ARINC 424 NDB

Draft 4 of Supplement 23
Discussion/Proposal

VERTICAL ANGLE CODING AT THE FAF

Julien ROBIN, Airbus

AIP FAA chart for RNAV(GPS)-27L at KPHL:

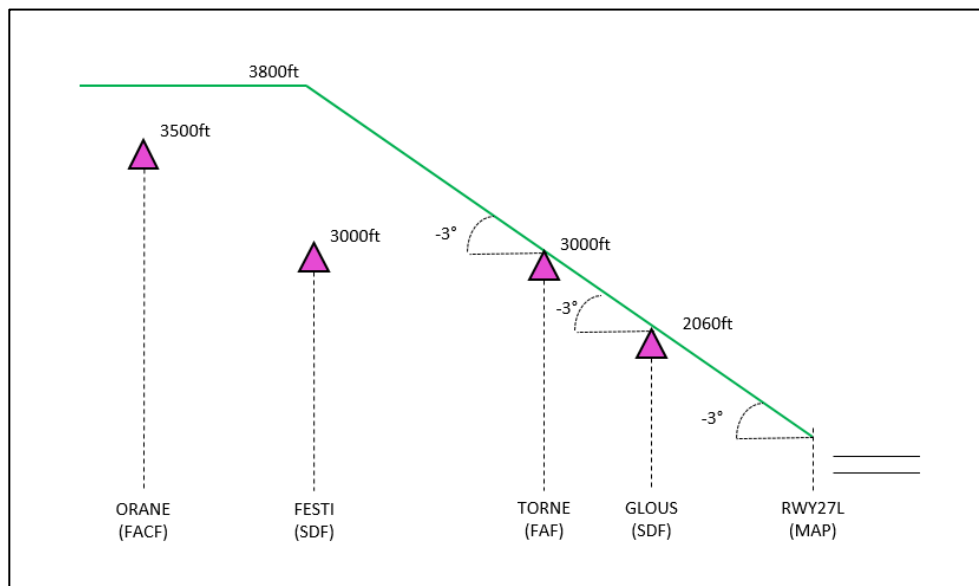
During tests performed in simulator in July 2020 by Airbus flight test department in order to validate changes made in the FMS' Navigation Database for FPA duplication at the FAF, Airbus found some occurrences at KPHL airport (Philadelphia US) where the vertical angle was still present at the FAF in the coding of the procedure. For instance, on RNAV(GPS)-27L at KPHL, the FAF TORNE has associated -3° vertical angle coded in the Navigation Database. As a result, the FMS builds a vertical approach profile with a -3° descent segment down to TORNE despite the AIP chart depicts a level-off at TORNE.

This discrepancy between published chart and automatic flight guidance performed by the A/C may create high confusion for the crew, calling into question the correct functioning of the FMS and the Navigation Database content.

After analysis with the NDB Provider and the Data Services Provider (DSP), it appeared the vertical angle was coded at the FAF on the RNAV approach by the DSP in order to satisfy ARINC 424 rule 8.9.9. Additional review performed by Airbus showed that another DSP does not code such vertical angle at the FAF (in accordance with the chart).

Airbus would like the rule 8.9.9 to be reviewed so that the coding of the vertical angle at the FAF is not to be performed unless clearly requested by the originator of the procedure (AIP source, chart, etc.). Indeed, there is a need that the coding of the procedure satisfies and correctly reflects what is published on the chart (both AIP source's chart and proprietary Data Provider's chart).

8.9.9 If one or more step-down fixes are published in the official government source in the intermediate approach segment of the procedure (**FACF to FAF**), and the intermediate approach segment can be included in the **fFinal aApproach Coding**, the fixes and the appropriate altitudes will be included as part of the Final Approach **Coding**. **If the official government source requires aA** vertical angle **to** will be coded on the FAF waypoint, **the vertical angle value that** will ensure that any step-down fix altitude in the **intermediate approach segment (FACF to FAF)Final Approach Coding, FACF, to the FAF** is cleared by that angle. Vertical angle information is not provided in Approach Transitions. **(H**however, any **such** fix **of the initial approach segment** will be included in the **Approach Transition eCoding**, along with the government source supplied altitudes).
